**To** City of Greater Geelong **Date** 10 March 2022  
**From** Cameron Munro **Project No.** 0182  
**Subject** Gheringhap Street and Moorabool Street bicycle lanes safety assessment

This safety assessment was commissioned by the council to provide an independent review of the as-constructed bicycle lanes at five locations:

■ **Figure 6.2: Park Crescent crossing (note gravel)**

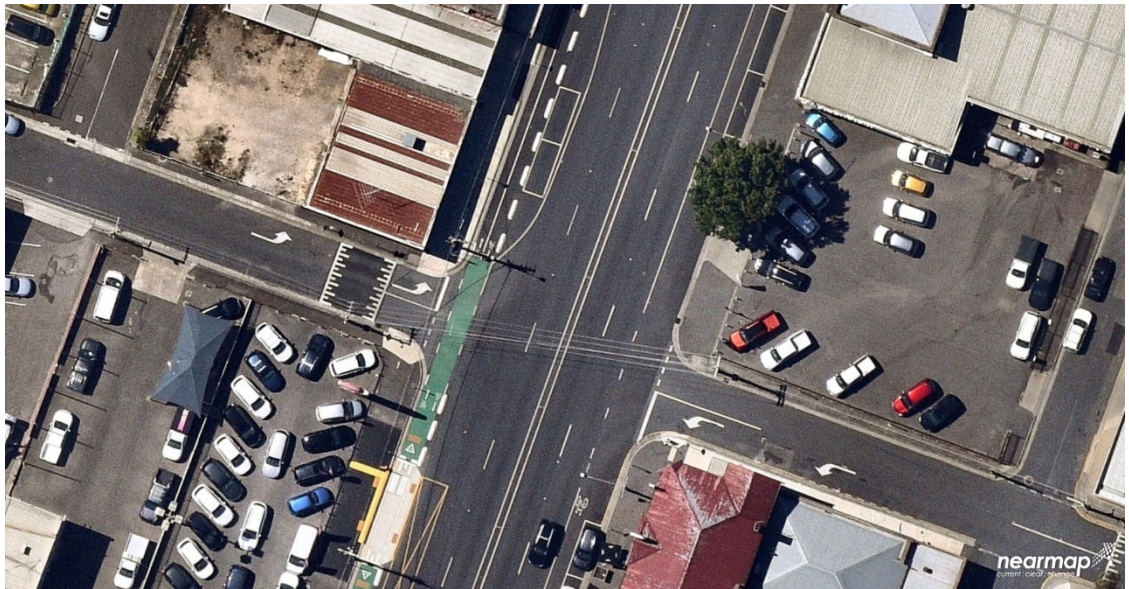
Sightlines at this intersection are good. At bi-directional cycleway crossings at T-intersections the critical movement is invariably vehicles emerging from the minor street turning left conflicting with bicycle riders travelling contraflow (i.e. southbound in this case). The setback of the crossing, along with the vertical deflection and good sightlines, will help to ameliorate but not eliminate this risk. Significant amounts of gravel was present around and on the crossing which could be a hazard; it is understood this was a result of heavy rainfall prior to the inspection and has subsequently been removed.

Overall, it is suggested this intersection is likely to be operating to a satisfactory level of safety. Should issues arise countermeasures may include:

- Install speed cushions upstream of the crossing for eastbound motorists on Park Crescent.
- Install bollards or kerb outstands at the north entry to tighten the corner radius and reduce the crossing distance for pedestrian and bicycle riders.
- Reconstructing the crossing with steeper ramp grades and an extended ramp to the west to encourage emerging motorists to slow farther away from the conflict point.
